**ADDENDUM NO (1) ONE
IFB 17-PW-003
Industrial Park Sewer Line Improvements**

October 20, 2016

Addendum Number (1) One forms part of the contract documents and modifies them in the manner set forth below.

PROJECT NAME
**CITY OF RIO RANCHO
INDUSTRIAL PARK
SEWER SYSTEM
IMPROVEMENTS**

SHEET NO:
G-004

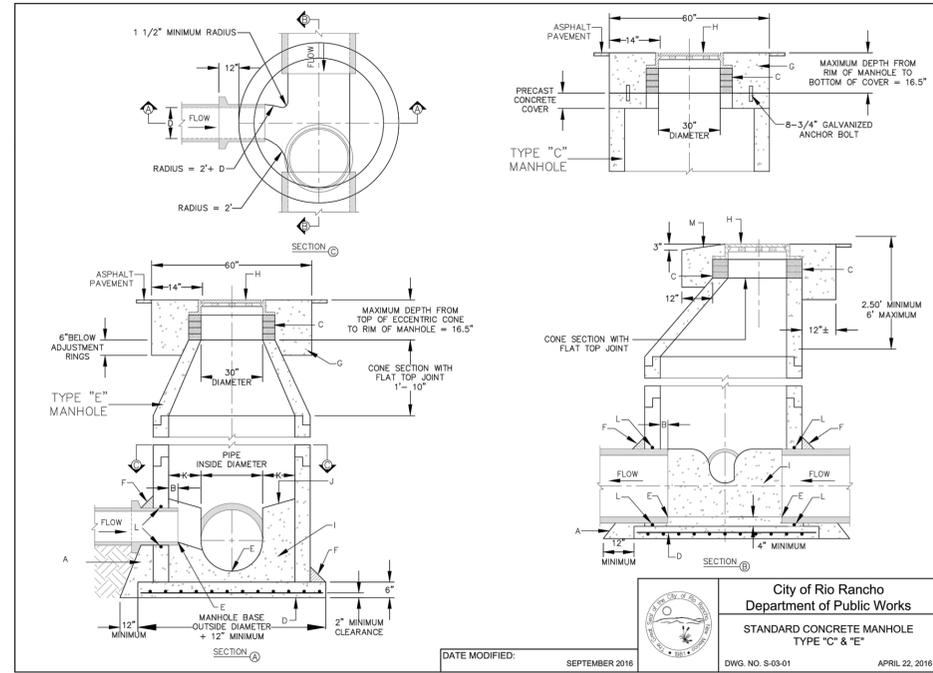
Question: Plan sheets C-201 thru C-203 call out 6" sewer Lateral Connections, while Bid Item #010 Calls for "4" PVC SDR-35 GRAVITY SANITARY SEWER LINE PIPE (SERVICE CONNECTION)" and WASTEWATER SAMPLING MANHOLE detail on sheet C-502 also Indicates 4" Service line. What size should the Services be, 6" or 4"?

Question: Item 4 is “Existing asphalt removal/disposal” paid by the linear foot. NMDOT Section 601.5 pays this item by the square yard. Can this item be changed to reflect the specifications?

Question: Item 16 is for a manhole, 3’ to 16 ‘ deep, which is not recognized by the referenced specifications, NMAPWA. Does this item refer to manhole #4 at Sta 21+96.45?

Question: There is no bid item for construction staking and as-builts by the Contractor. Is the City of Rio Rancho providing the surveying for this project?

Answers: Bid item #010 should be for 6" service. See updated bid form attached hereto.

Answers: See updated bid form for revised bid item.

Answers: See updated bid form. Item refers to Manhole 7.

Answers: See updated bid form for added bid item.
